Post Pour Concrete Slab Report

Inspection Date: 9 Apr 2020

Property Address: Rockbank Area - Melbourne

Report Type: New Home Construction

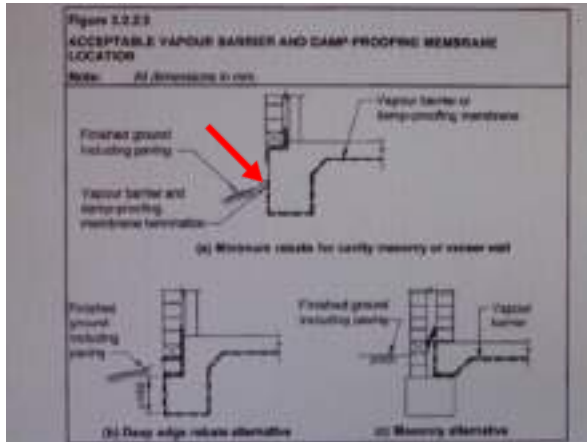
Finding: Polyethylene vapour barrier not installed as per BCA - Part 3.2.2.6

It was noted at the time of inspection that a vapour barrier had not be installed in accordance with AS2870 and BCA Part 3.2.2.6.

All of the vapour barrier system has NOT been done correctly and ALL areas of non compliance is required to be repaired.

- 1/ All over laps are not taped as described below.
- 2/ All the rips and/or damaged area needs to be taped.
- 3/ ALL areas are not up to future ground and/or finished paving or concrete heights and must be extended with 200mm overlay and taped.
- 4/ Somes areas whilst listed above are Damaged / Ripped / Not Consistent And Sealed with 200mm Overlay And Taped / Not High Enough / Non Existent must ALL be repaired.

The polyethylene vapour barrier from beneath the concrete floor slab must be turned up the external side faces of its edge beams. Failing to install the vapour barrier correctly will allow moisture ingress via slab edge dampness into the internal timber wall skins and/or the floor coverings if not done.

The polyethylene vapour barrier must properly extended up the external side faces of the edge beams to at least 600mm above the height of the slab for now and then at future finished ground level of the solid, concrete , etc.

(c) The vapour barrier must be placed beneath the slab so that the bottom surface of the slab is entirely underlaid and extends under edge beams to finish at ground level in accordance with Figure 3.2.2.3.
